Response to Agency Comments on the Butte Priority Soils Operable Unit (BPSOU) Draft Blacktail Creek Groundwater Hydraulic Control System Pre-Design Investigation Evaluation Report Prepared for Atlantic Richfield Company By Stantec Consulting Services, Inc. Dated September 12, 2024 Date of Comments: February 1, 2024

**Response to Agency Comments on the
Butte Priority Soils Operable Unit (BPSOU) Draft Blacktail Creek Groundwater Hydraulic
Control System Pre-Design Investigation Evaluation Report
Prepared for Atlantic Richfield Company
By Stantec Consulting Services, Inc.
Dated September 12, 2024
Date of Comments: February 1, 2024**

4.5.2 Steady state vs Transient Discharge (41b)

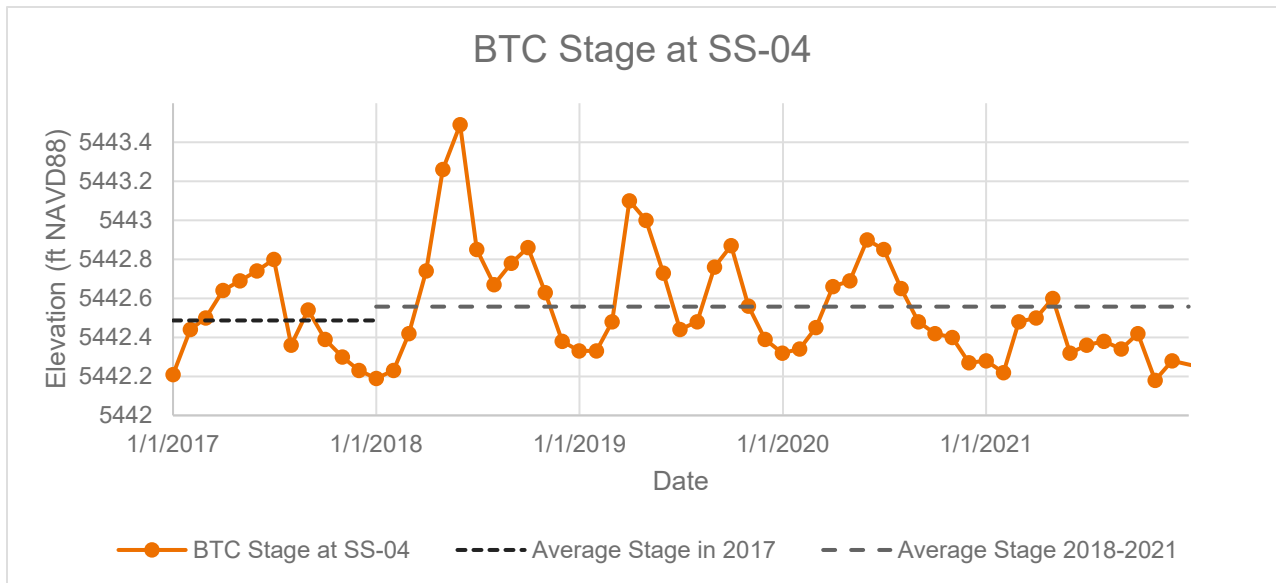
Comments: "For this transient simulation, it is stated in Section 8.2.6 of the Groundwater Model Technical Memorandum that "the simulated flux values [from below and from the northeastern side of BTC to the SFR boundaries] for Alternative 6 ranged from 0.0017 cfs to 0.0043 cfs".

In the preceding paragraph, it is stated that for the steady-state simulation, the same flux values total 0.004 cfs.

Are these flux values for the same reach of BTC and for the same model cells? If so, is there a reason that the steady-state (average condition) value is near the max value from the transient simulation? Similarly, an abrupt reduction in flow over the first-time step is noted in the Alternative 6-time history plot in Figure C-8.11. The precipitation and recharge patterns shown in Figure C-3-5 don't indicate that 2017 steady-state flows should be much higher than the 2018-2021 average." (41b)
